PARTIAL MECHANICAL DUCTWORK PLAN - THIRD FLOOR
 CANADA COLLEGE - BUILDINGS 5 & 6 RENOVATIONS
 RFI 0173 MSK-02

RFI-173

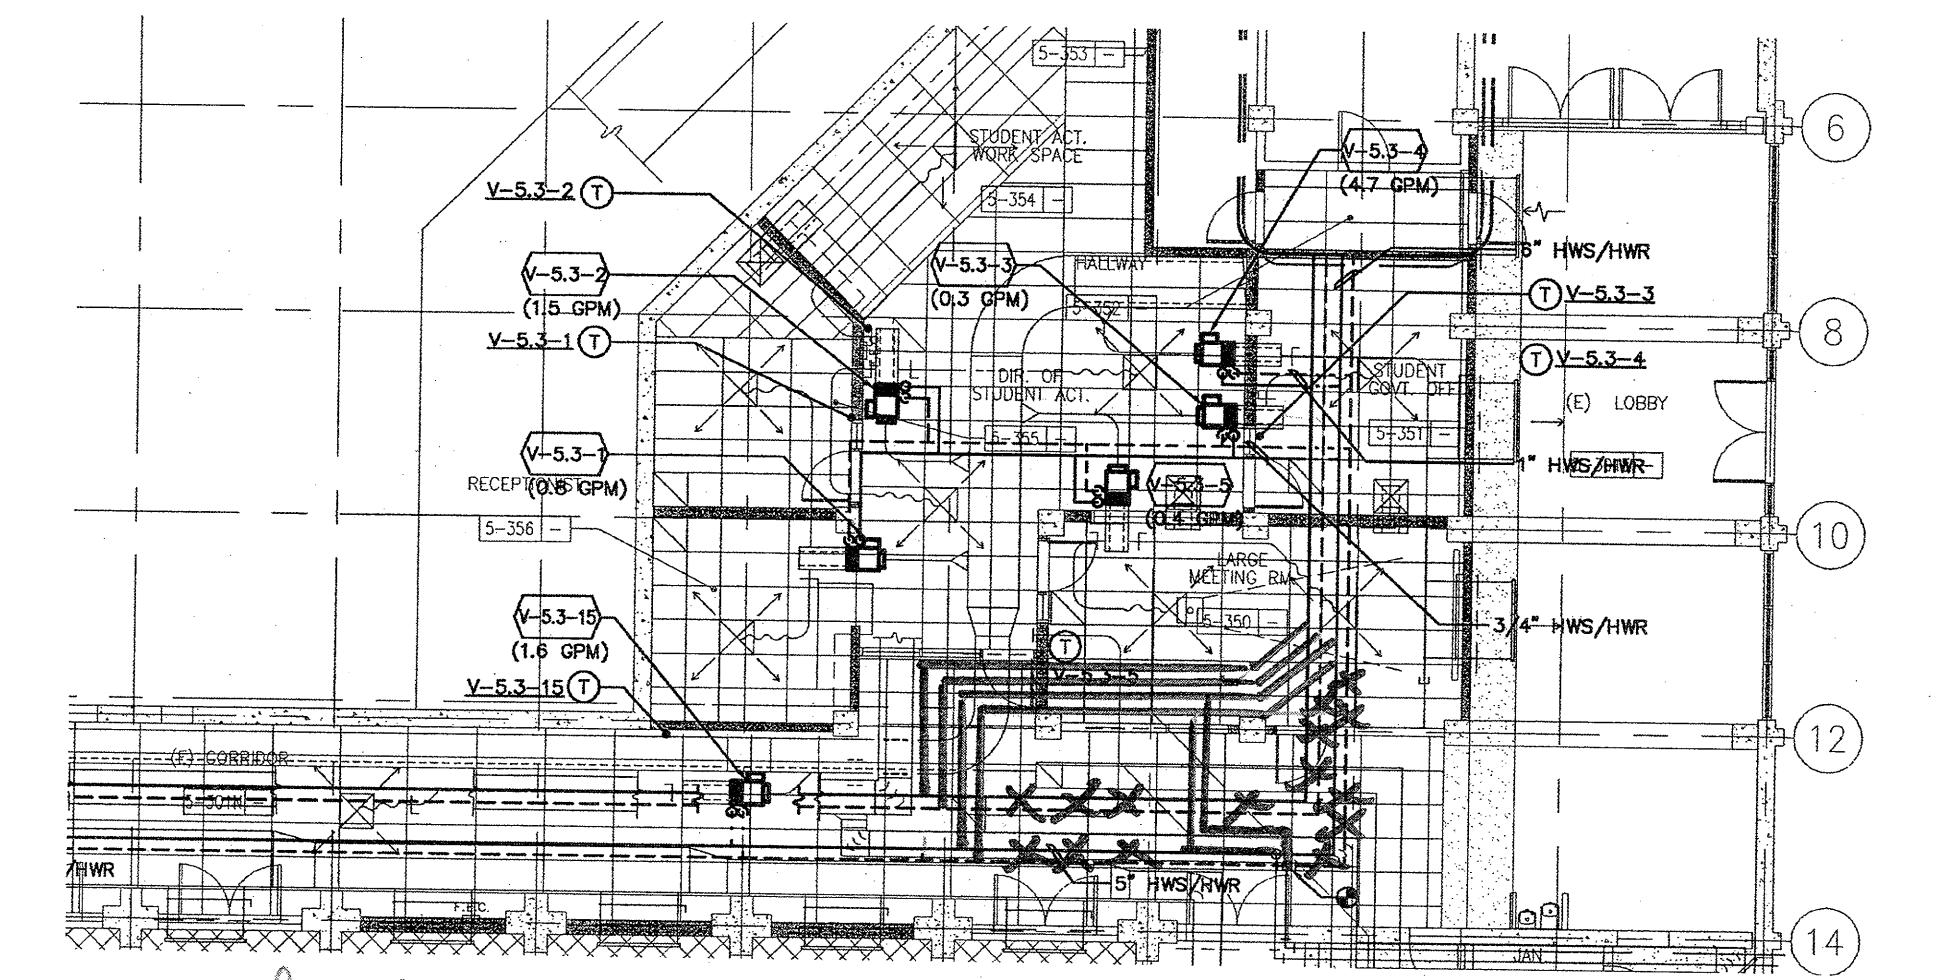
Reroute of HWS (HWR, CHWS/CHWR main's
 to maintain 9'0" ceiling height in Corridor 5-301N
 Peibuss 8-18-10 Sketch PRI#001
